# IREDELL COUNTY HEALTH DEPARTMENT

## IMPROVEMENT PERMIT / AUTHORIZATION TO CONSTRUCT / OPERATION PERMIT / EXISTING SYSTEM INSPECTION

PERMIT# 17080 PIN# 4629-84-1655

LOT 874 STILLWATER ROAD
DAVIDSON TOWNSHIP
IREDELL CO., N. C.

INITIAL SITE SKETCH

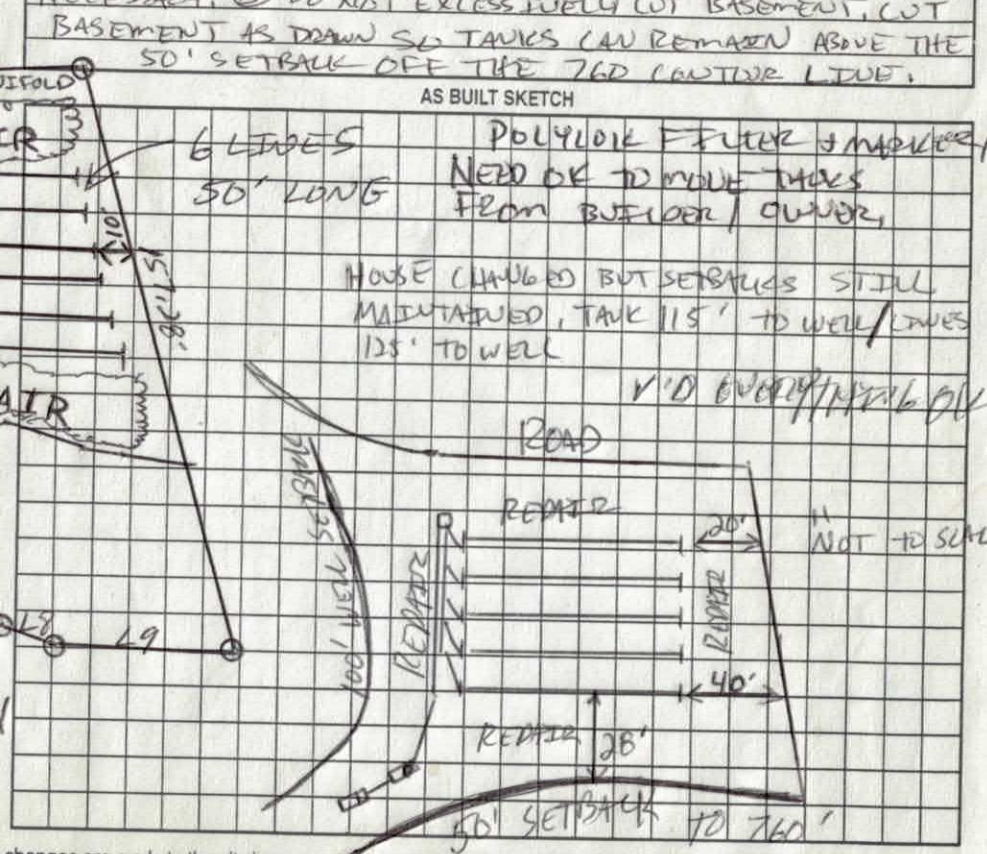
Comments:/Conditions: ① HOUSE SITE & P/L'S MARKED & PLATTED BY A SURVEYOR ② SYSTEM IS FLAGGED OUT COMPLETELY ③ MAINTAIN SETBACKS ④ CALL PRIOR TO INSTALLATION

Comments:/Conditions: FOR PUMP SIZING DIAGRAM & SPECS IF NECESSARY. ⑤ DO NOT EXCESSIVELY CUT BASEMENT, CUT BASEMENT AS DRAWN SO TANKS CAN REMAIN ABOVE THE 50' SETBACK OFF THE 760 CONTOUR LINE.

[redacted] SITE SKETCH

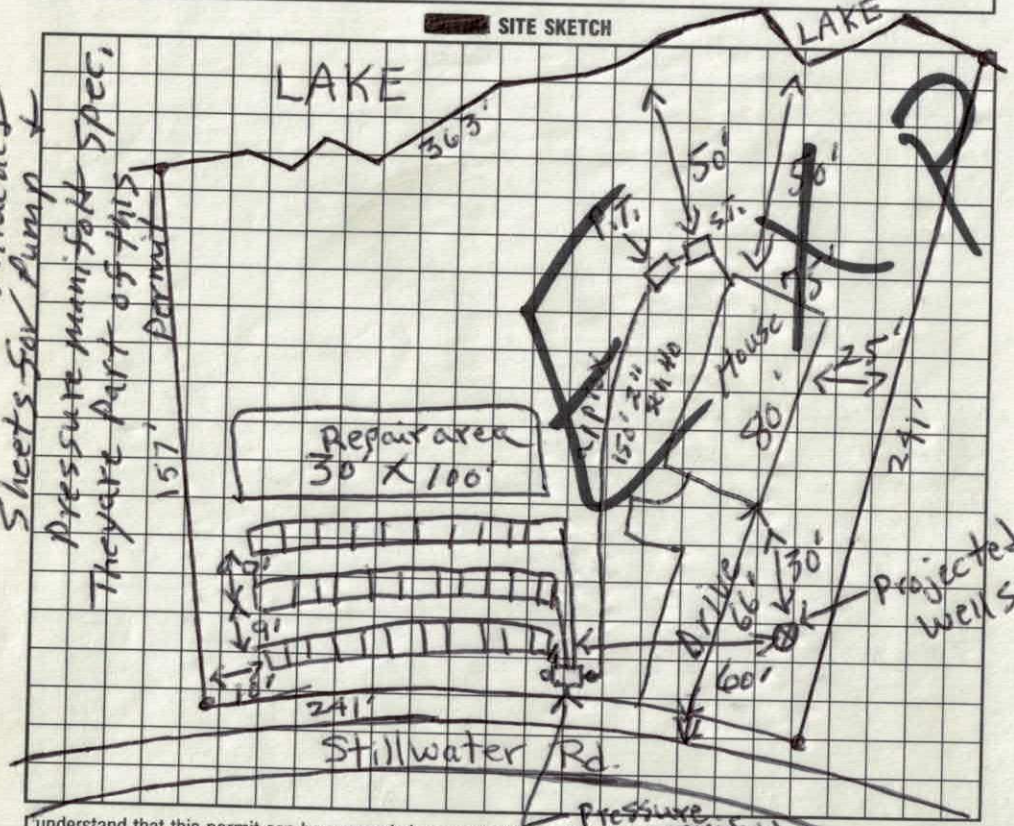
Comments: Inspection Port Should be installed on each line amount of line is Equal to 400' of convortional
